Access Compliance Report

Public Rights-of-Way

Intersection ID: 11686	Main Street: BRISTOL_DR	Cross Street: CARLYLE_DR	Location: SW
ADA ID: 2A685B32BF48	Ramp Type: BlendTrans2	Initial Pass/Fail: Fail	Overall Compliance: No
		Severity Score: 10

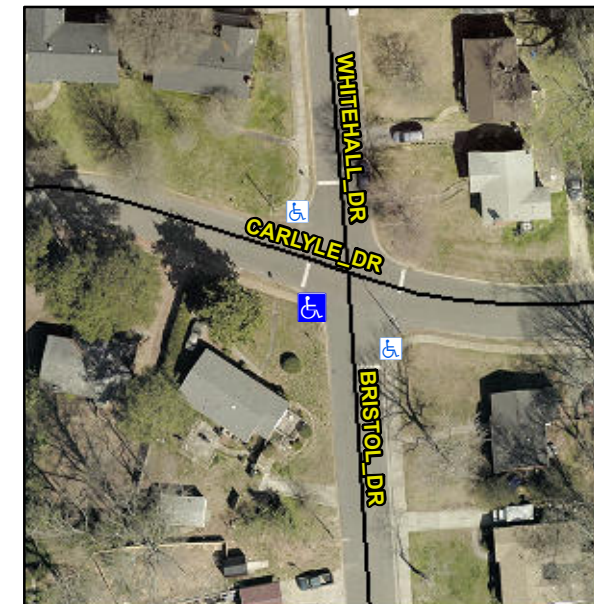
Not Found, R304.5.1, R304.5.3

Compliance	Description	Data	Compliance	Description	Data
N/A	Ramp Length (in)	57.5	Yes	BlendTrans Slope (%)	3.9
No	Ramp Width (in)	41.0	No	BlendTrans XSlope (%)	2.6
N/A	Flare Type LT	N/A	N/A	Flare Type RT	N/A
N/A	Flare Slope LT (%)	N/A	N/A	Flare Slope RT (%)	N/A
N/A	Flare Traversable LT?	N/A	N/A	Flare Traversable RT?	N/A
N/A	Landing Length (in)	N/A	N/A	DWS Provided?	N/A
N/A	Landing Width (in)	N/A	N/A	DWS Contrast?	N/A
N/A	Landing Slope (%)	N/A	N/A	DWS Length (in)	N/A
N/A	Landing X Slope (%)	N/A	N/A	DWS Full Width?	N/A
N/A	Landing Curb? (Y/N)	N/A	N/A	DWS Offset (in)	N/A
N/A	Shared Landing?	N/A			
N/A	Gutter Ponding?	N/A	N/A	Gutter Slope (%)	N/A
N/A	Gutter Lip Ht (in)	N/A	N/A	Gutter X Slope (%)	N/A
N/A	Painted X Walk1?	No	N/A	Painted X Walk2?	No
	X Walk 1 Direction	To SE		X Walk 2 Direction	To N
	X Walk 1 Width (in)	N/A		X Walk 2 Width (in)	N/A
	X Walk 1 Slope (%)	0.5		X Walk 2 Slope (%)	3.9
	X Walk 1 X Slope (%)	4.3		X Walk 2 X Slope (%)	0.6

N/A	Ramp inside XWalk1?	N/A	N/A	Ramp inside XWalk2?	N/A
	Road Slope (%)	2.7		Clear Space?	N/A
	Road X Slope (%)	4.6	N/A	Clear Space to XWalk (in)	N/A
N/A	Any Obstructions?	N/A	N/A	Storm Grate/Utility Hazard?	N/A
	Obstruction Type			Storm Grate/Utility Type	
		N/A			N/A
			Yes	Surface Condition? (G/P)	Good
			No	Curb Slope (%)	28.2

Remove & Replace Curb Ramp With Two New Directional Ramps or Equivalent.
